Response to
Request for Additional Information No. 467 (5333, 5344)
Supplement 15

U.S. EPR Standard Design Certification
AREVA NP Inc.
Docket No. 52-020

SRP Section: 03.06.03 - Leak-Before-Break Evaluation Procedures
SRP Section: 03.09.02 - Dynamic Testing and Analysis of Systems Structures and
Components
Application Section: FSAR Chapter 3

Question 03.06.03-28:**Follow-up to RAI 265, Question 03.06.03-26**

Figure 3.6.3-8—Minimum Moment versus Circumferential Crack Leakage ~~Crack~~ Sizes for 1 gpm in Main Steam Line Piping

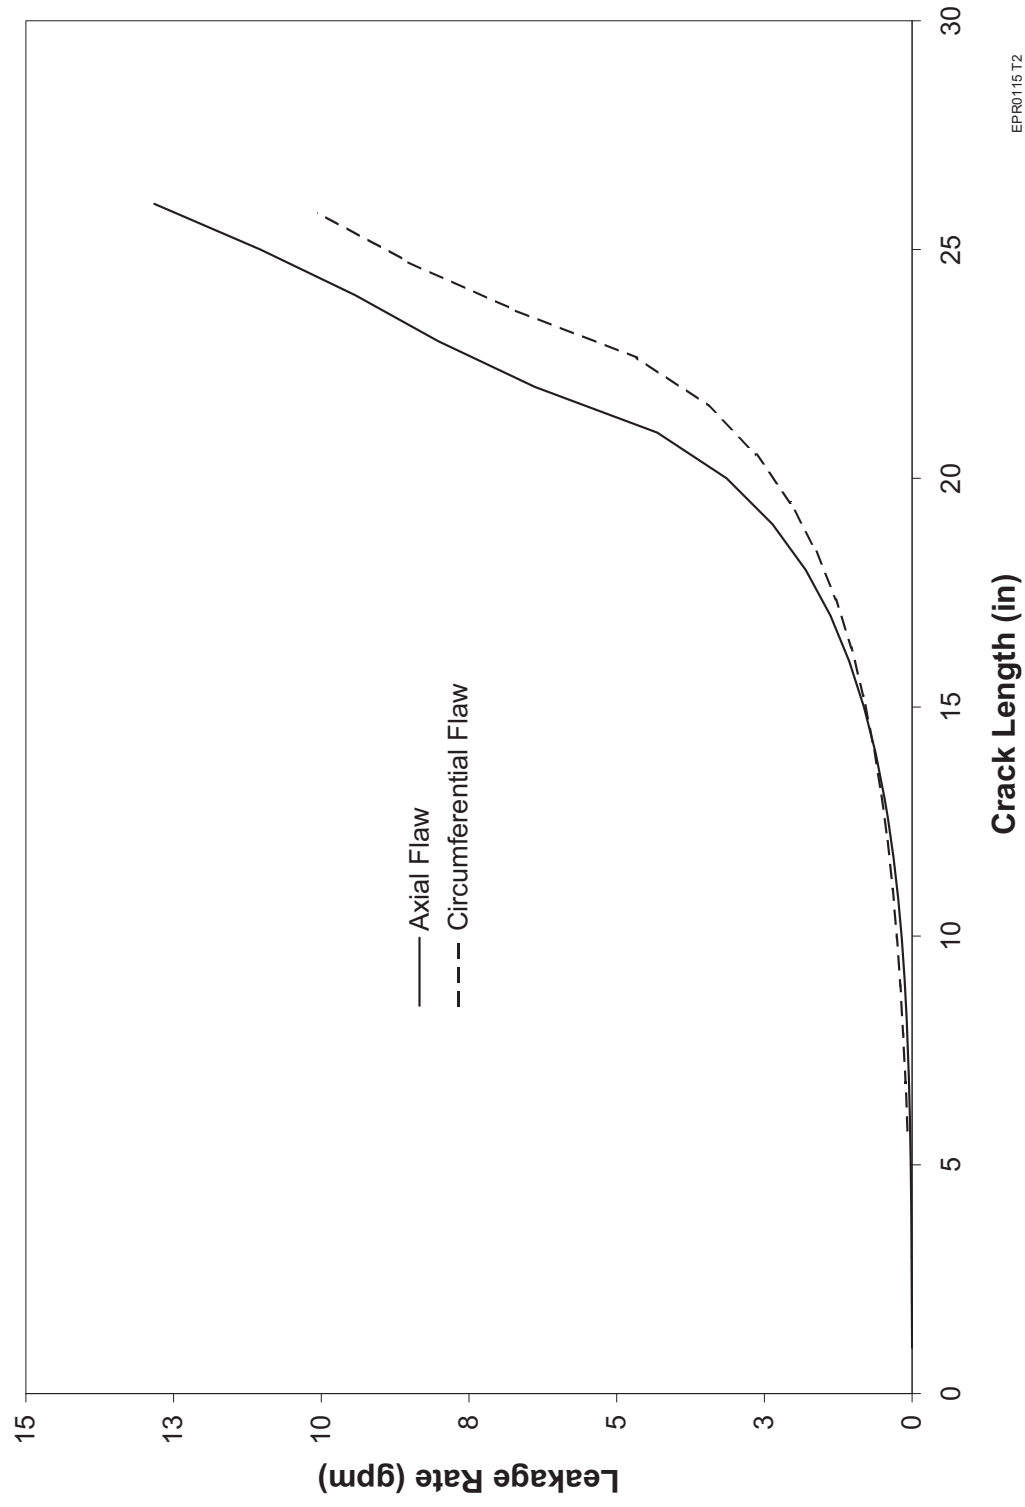
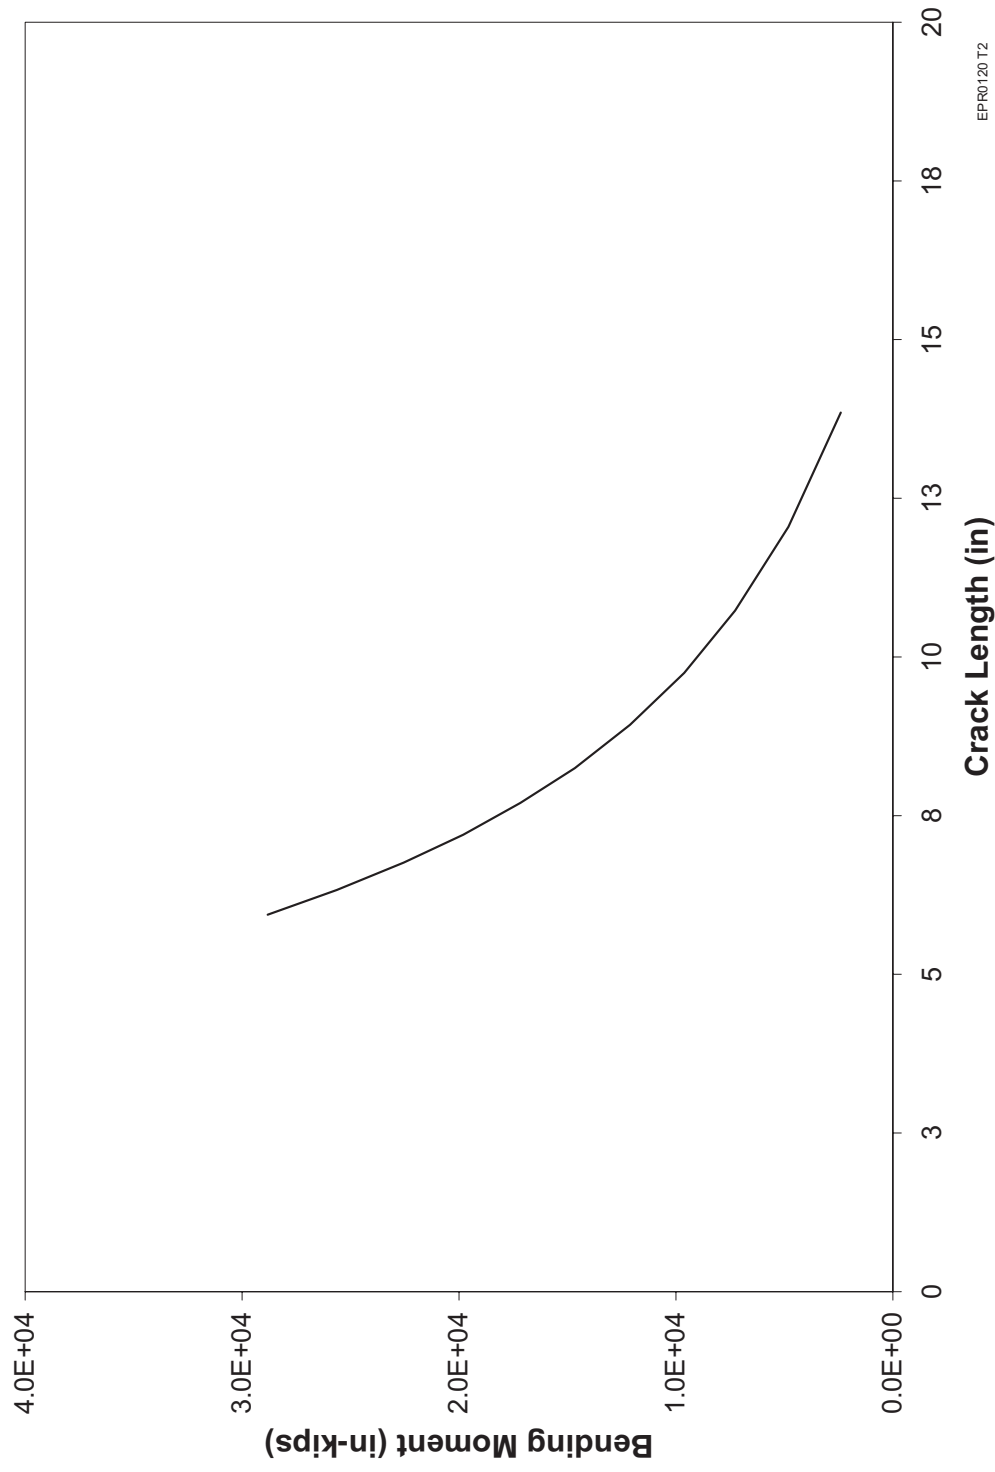
- The leakage calculations for the MSL line were determined using SQUIRT with single phase steam, and the fatigue crack morphology was used demonstrating that the recommended number of turns was used. The NRC also performed independent confirmatory analysis and had similar leakage results to those performed by AREVA NP.

- The MSL contains no dissimilar metal welds; therefore, no equivalent material properties calculations are needed.
- The reference strain in the Ramberg-Osgood (R-O) was correctly defined as the ratio of reference stress to the elastic modulus. The Response to RAI 265, Supplement 5, Question 03.06.03-26 corrected a typing error of the reference strain values for the MSL piping in U.S. EPR FSAR Tier 2, Table 3.6.3-7 (the reference strain values varied by an order of magnitude). In the calculations for the MSL, since the reference strain was calculated explicitly as the ratio of reference stress to the elastic modulus, the correct value was used. Therefore, the correction to the reference strain values in U.S. EPR FSAR Tier 2, Table 3.6.3-7 did not affect the ALL diagrams for the MSL in U.S. EPR FSAR Tier 2, Section 3.6.3.

Figure 3.6.3-12—ALL for Reactor Vessel Outlet Nozzle Region at Hot Leg (Location 1)

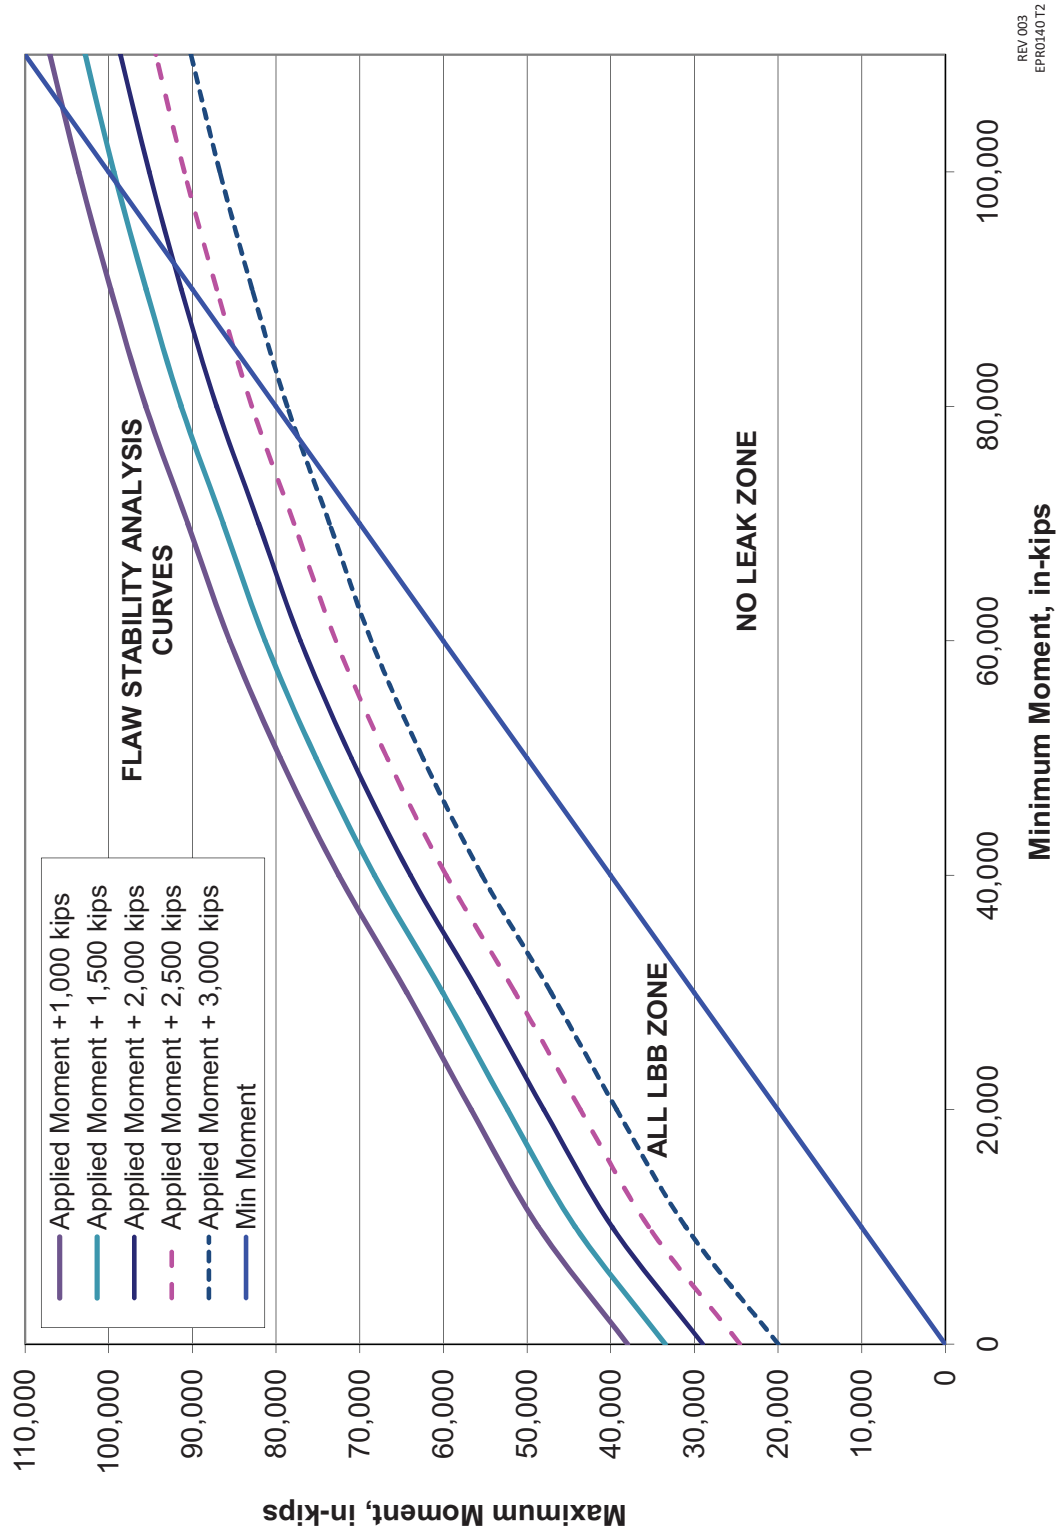
The Allowable Load Limit (ALL) Diagrams are presented in FSAR Tier 2, Section 3.6.3, Figure 3.6.3-12 through Figure 3.6.3-23 for the Main Steam Line (MSL), Main Coolant Line (MCL), and the Surge Line (SL) cases. As a result of the confirmatory calculations performed by the staff and the resulting RAI 265 Question 03.06.03-26, AREVA proposed (i.e., in its Supplemental 5 response to RAI 265 dated September 30, 2010) revising FSAR Tier 2, Figures 3.6.3-18, 3.6.3-19 and 3.6.3-20. Based on a telephone conference call with the applicant on April 7, 2010, the staff understood that AREVA would also revise the remaining ALL diagrams for MCL, MSL, and SL per the same procedure used for the SL. As stated in the telecon dated December 15, 2010, AREVA is requested to provide the NRC staff with revised versions of FSAR Tier 2, Figures 3.6.3-12,-13,-14,-15,-16,-17,-21,-22, and -23.

As noted in the question, the revised ALL diagrams for the SL were provided to the NRC in the Response to RAI 265, Supplement 5, Question 03.06.03-26. U.S. EPR FSAR Tier 2, Section 3.6.3 will be revised to include the revised ALL diagrams for the MCL. Corresponding changes will be made to the text and tables. The ALL diagrams for the MSL do not need to be revised for the following reasons:

Figure 3.6.3-24—ALL for RCP Outlet Nozzle (Location 7)

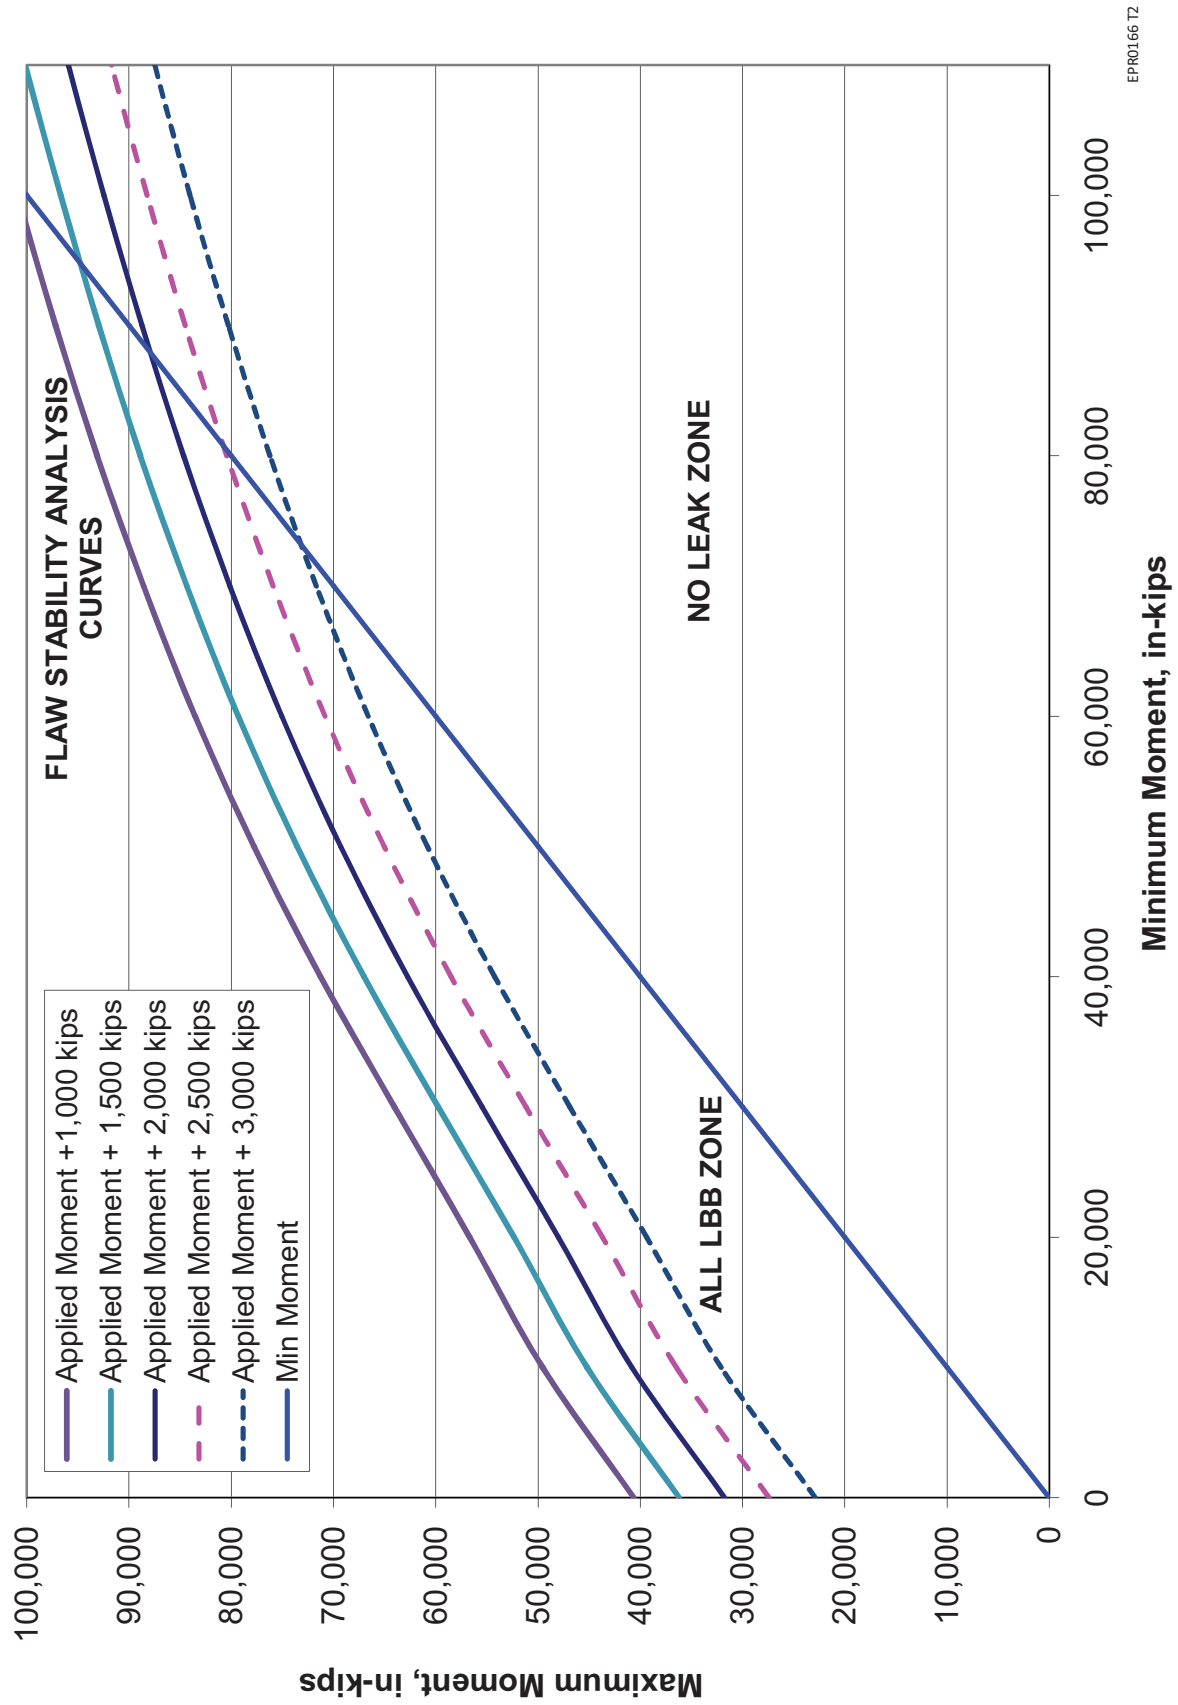
RAI 467
03.06.03-28
